**APPENDICES  
for  
Evaluation of the Cost Impact of 2024 ICC Prescriptive Code Changes**

RINKER-CR-2024-101

15 April 2024

**FIGURE AY102.1(1) Extended Plate Wall (EPW)**

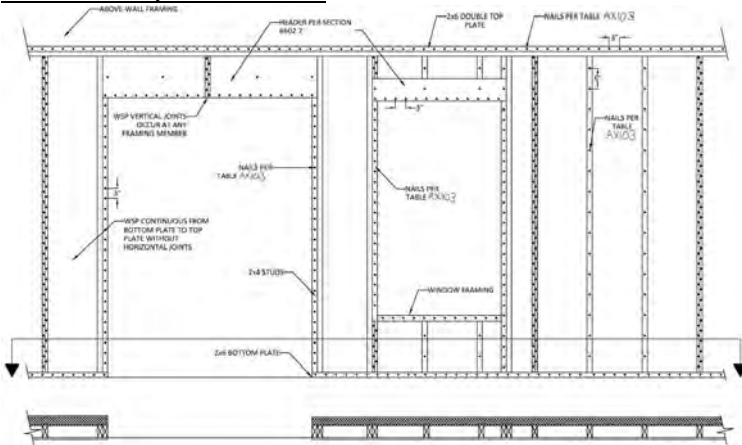
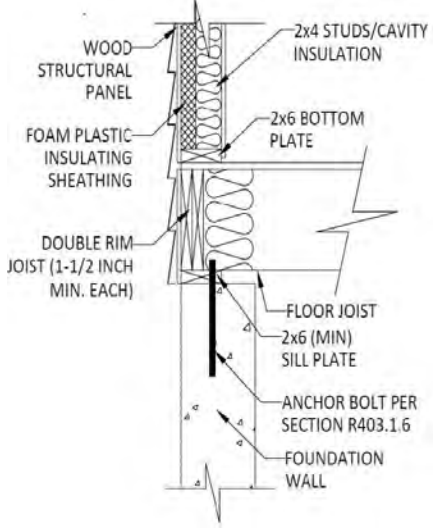
*(Reference in note on bottom left should be to AY102.4)*

**FIGURE AY102.1(2) Extended Plate Wall, Elevation View**

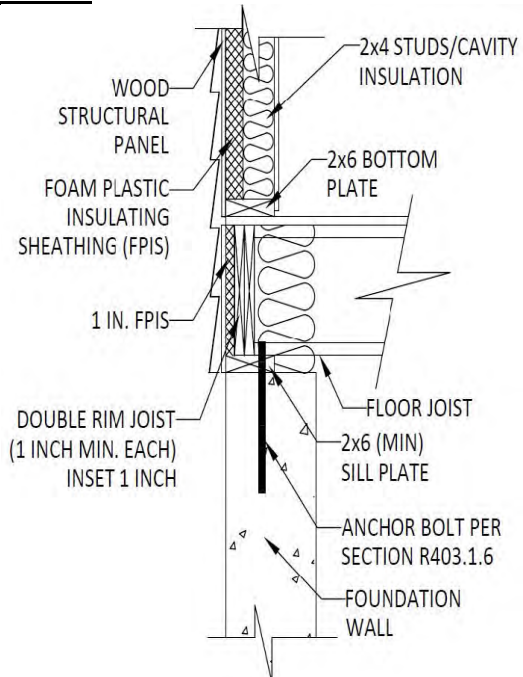
*(Reference in Figure should be to AY102.2 (6 locations))*
